- Subject: FURTHER INFORMATION FOR THE FINAL RESPONSES DATED JULY 24, 2012, TO NRC REQUESTS FOR ADDITIONAL INFORMATION DATED MAY 1, 2012, ON THE JANUARY 16, 2012, HEMATITE 20.2002 ALTERNATE DISPOSAL REQUEST (LICENSE NO. SNM-00033, DOCKET NO. 070-00036)

Responses and Related Document Page Changes to NRC Comments on the Additional 20.2002 Request Documents Submitted via Westinghouse Letter HEM-12-88, dated July 24, 2012

#### Responses and Related Document Page Changes to NRC Comments on the Additional 20.2002 Request Documents Submitted via Westinghouse Letter HEM-12-88, dated July 24, 2012

Figure 6-5, Graph of Surface Activity (count rate) Versus Total Uranium Activity

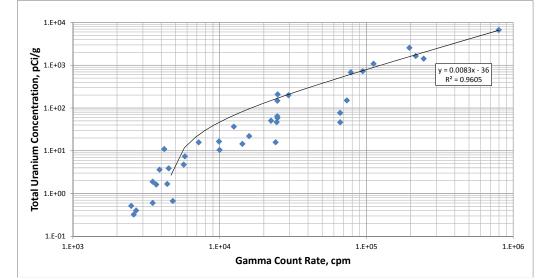
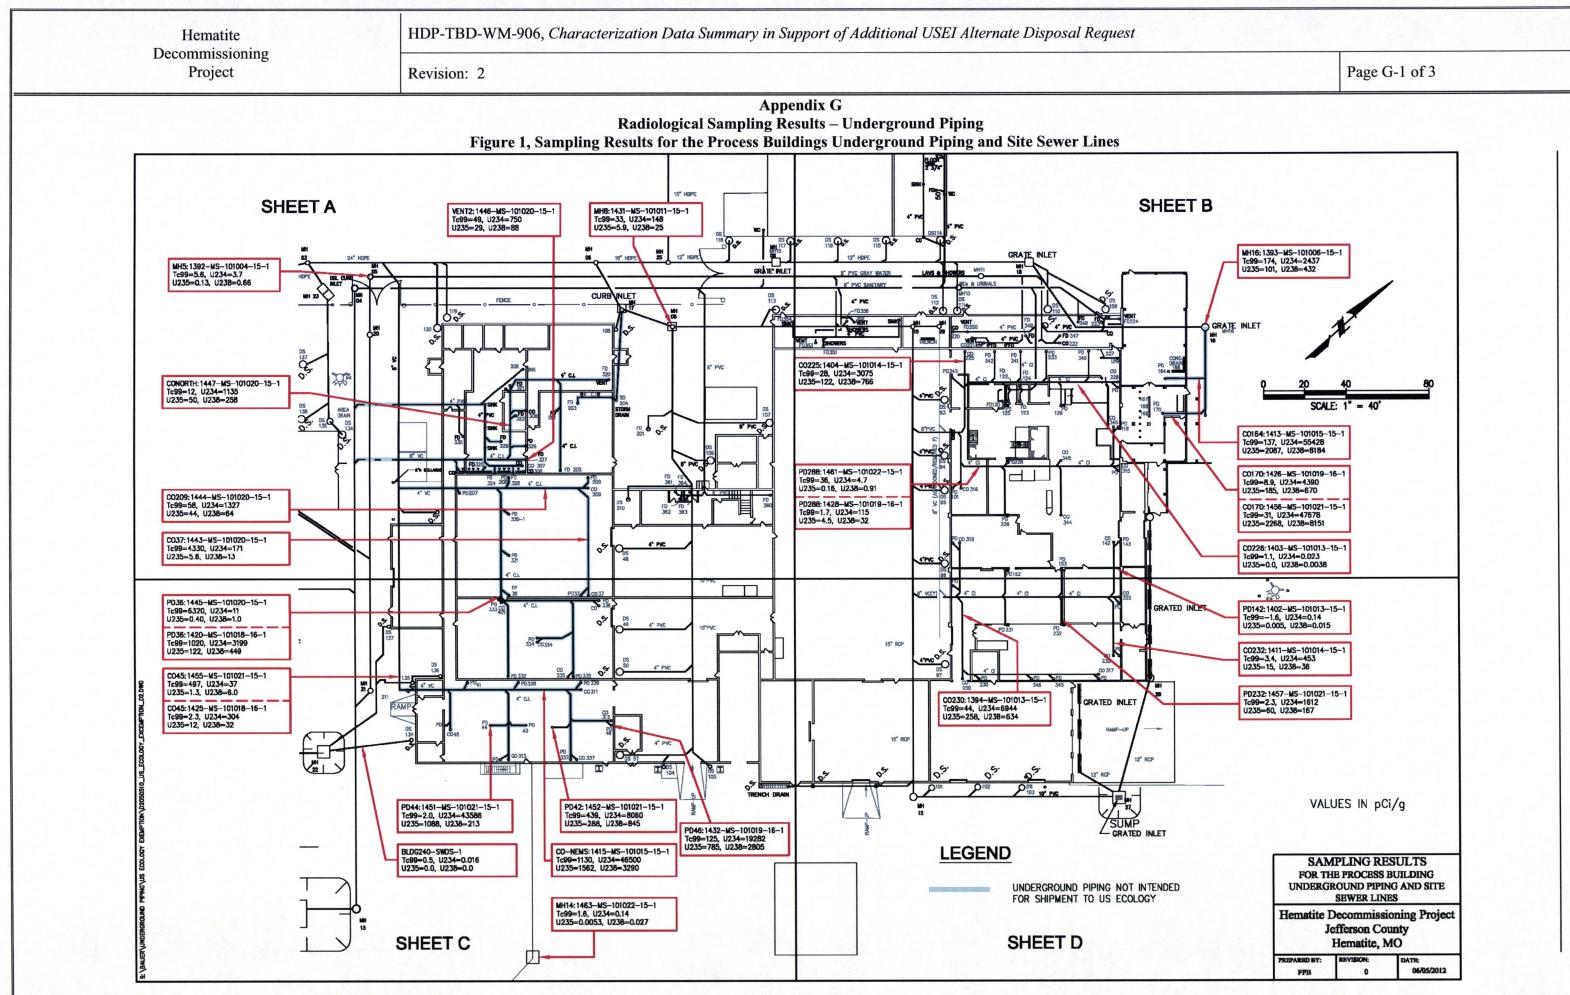
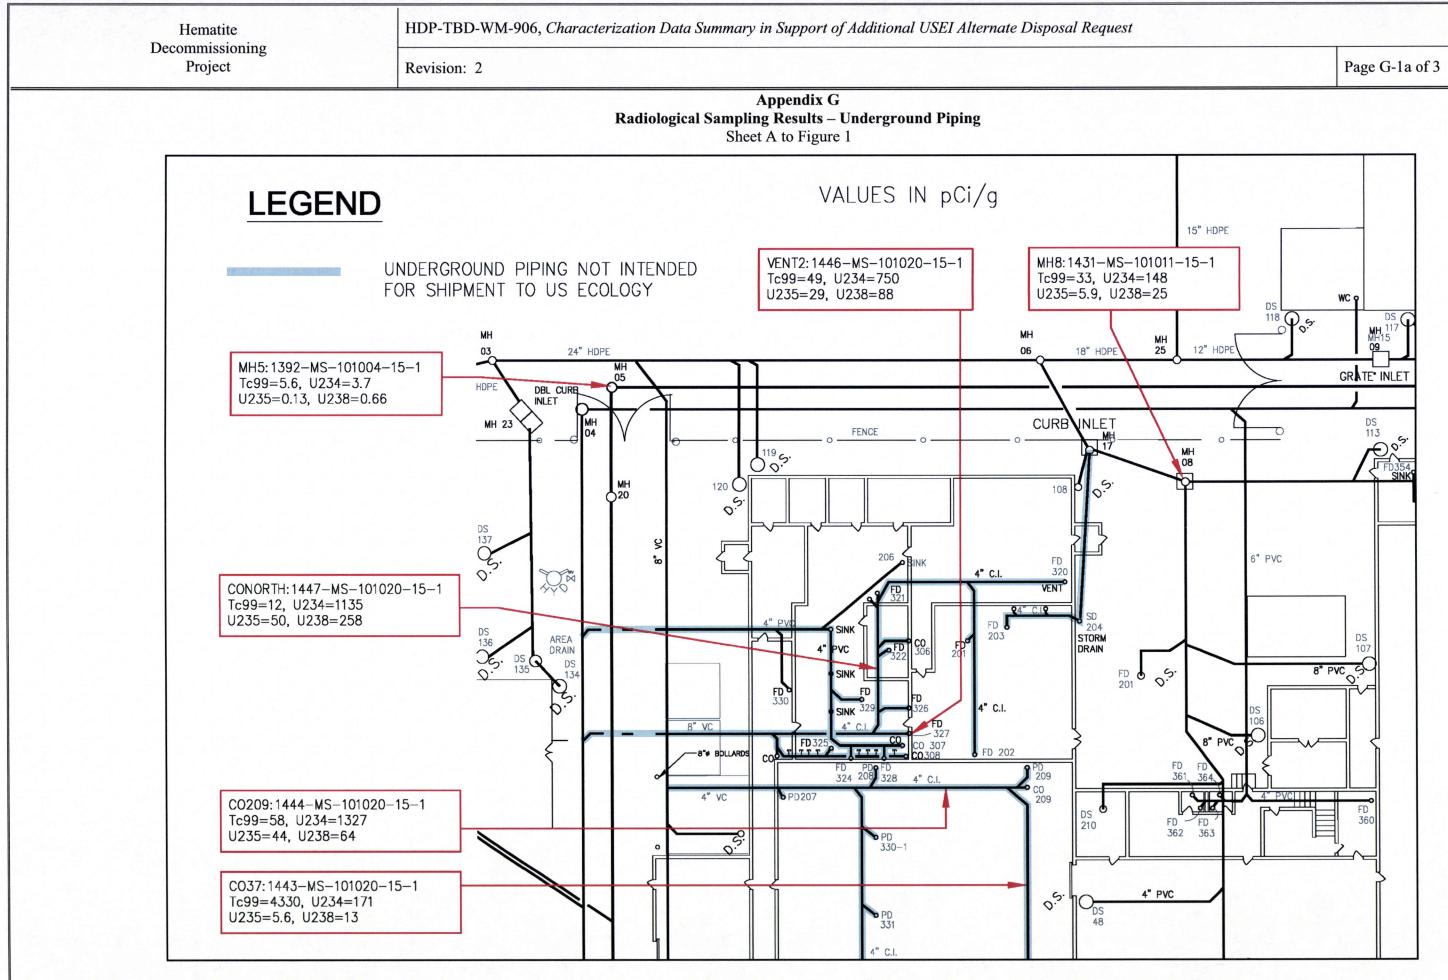
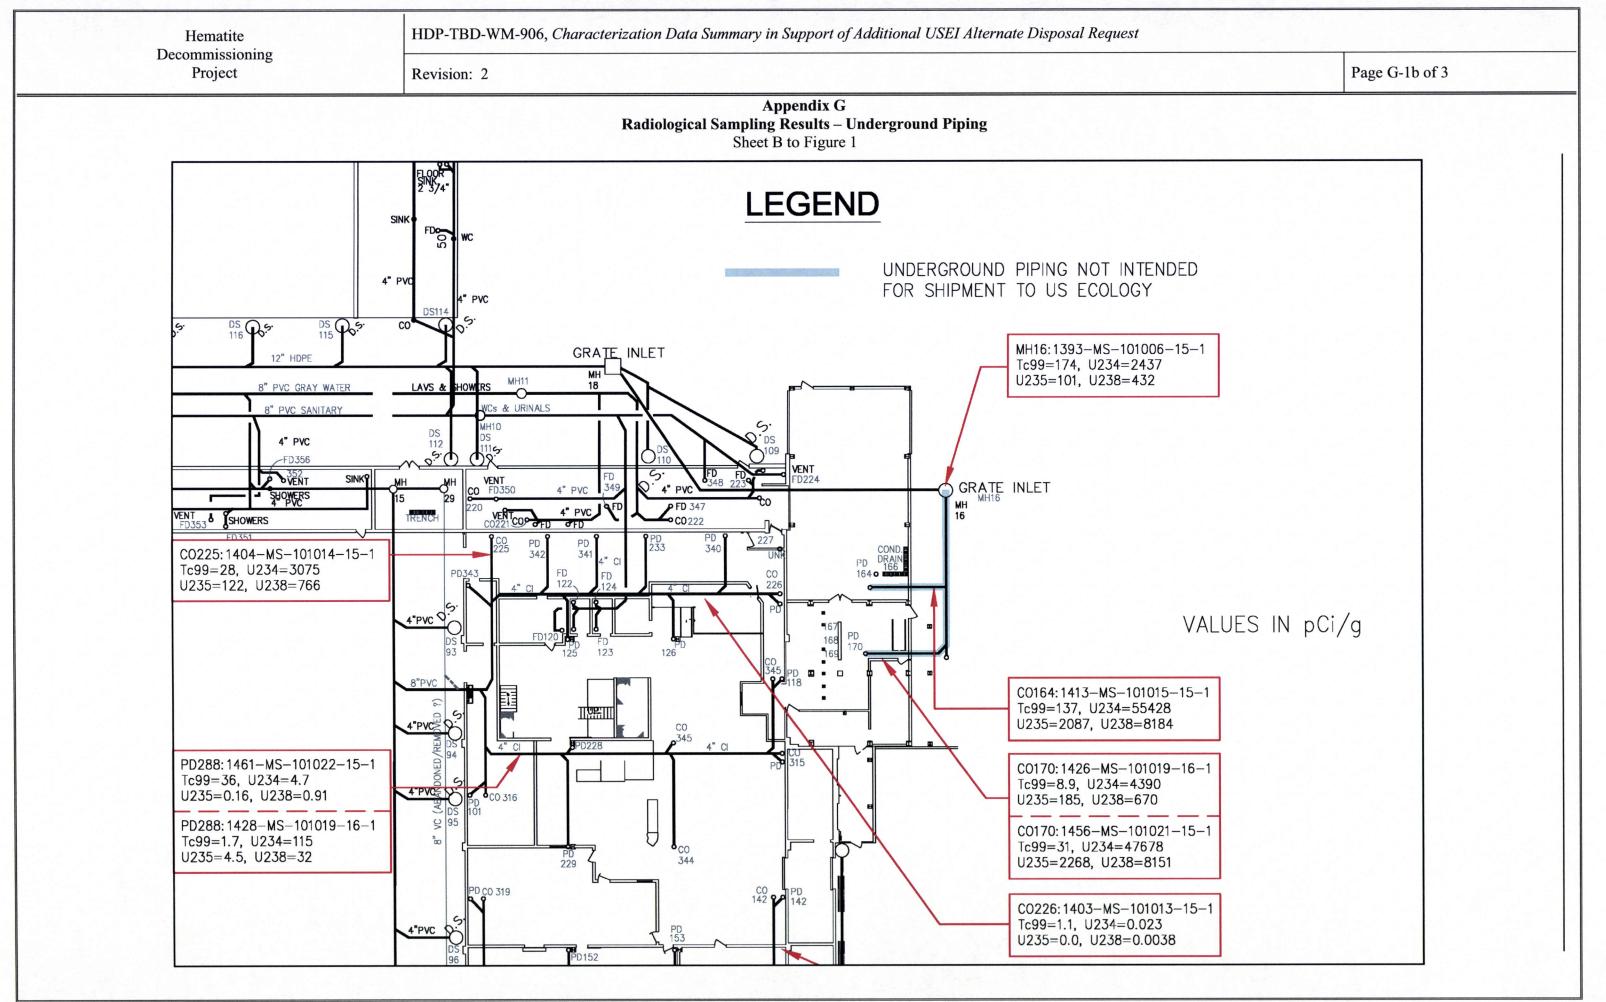
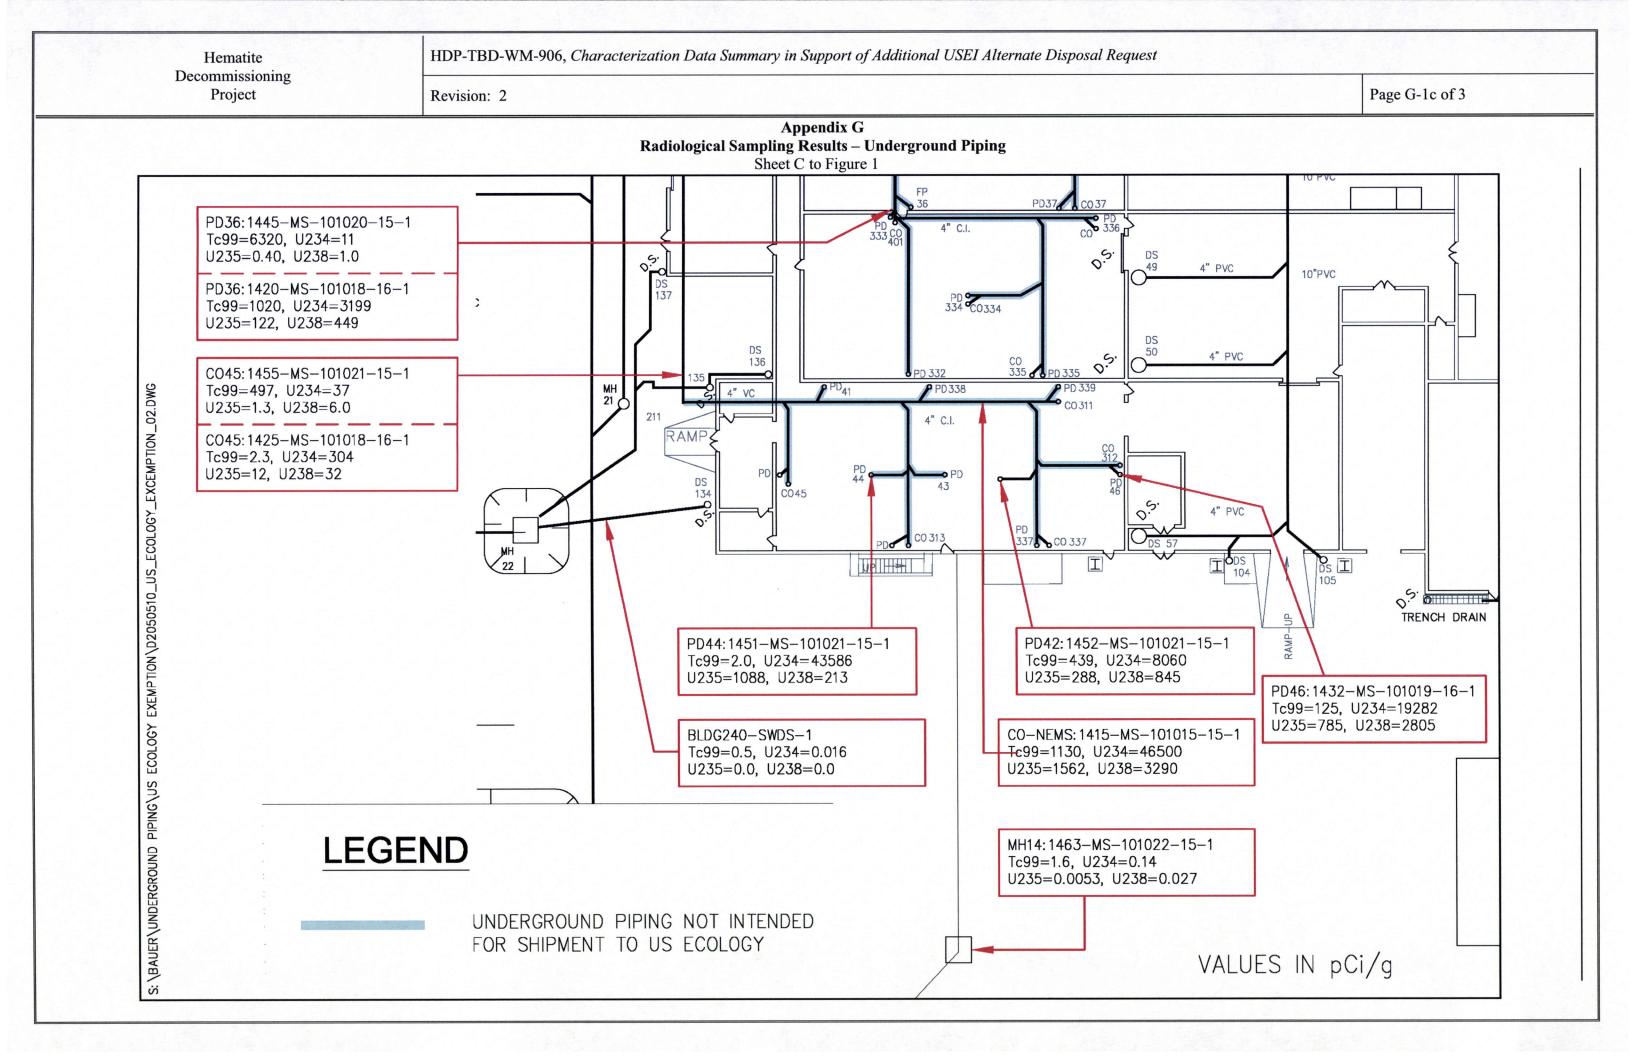
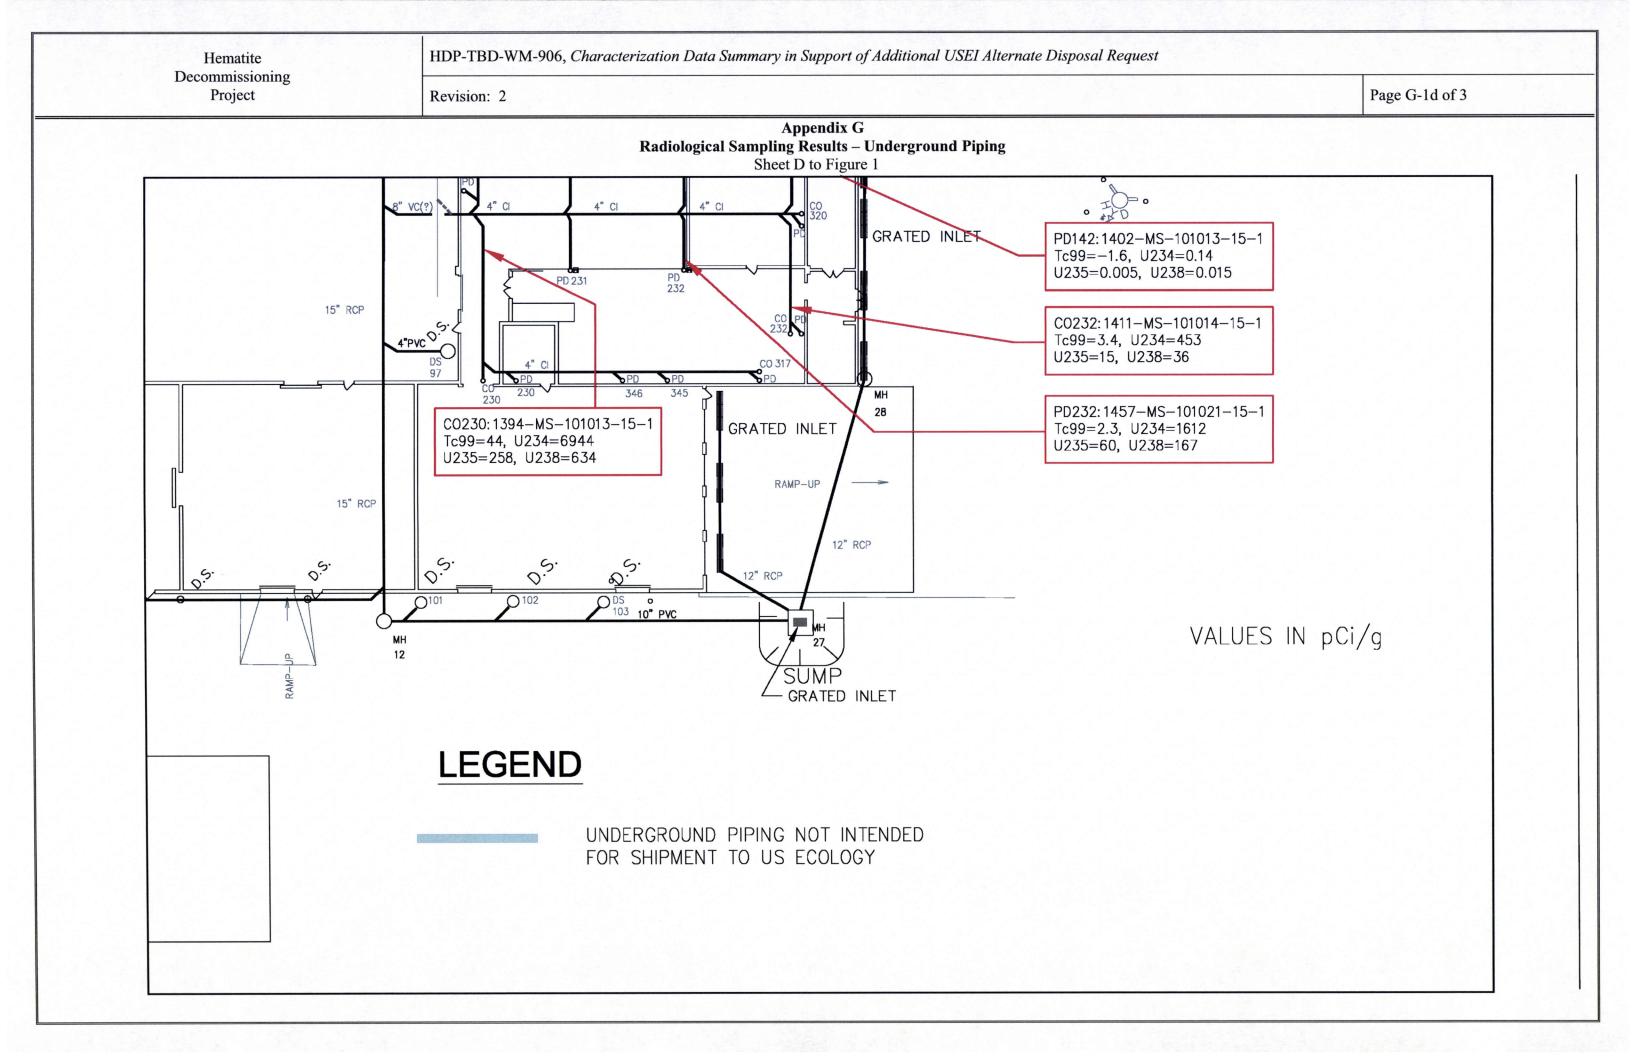
#### NRC Comment:

Westinghouse noted that Figure G-1 to HDP-TBD-WM-906 was not revised as stated in Westinghouse letter HEM-12-67; page changes for Figure G-1 are included in this enclosure.

The axis for the plot in Figure 6-5 was selected to indicate 0.4 pCi/g total uranium at a gamma count rate of 4400 cpm. These values were selected to represent ambient conditions based on the baseline gamma response within the building and on the total
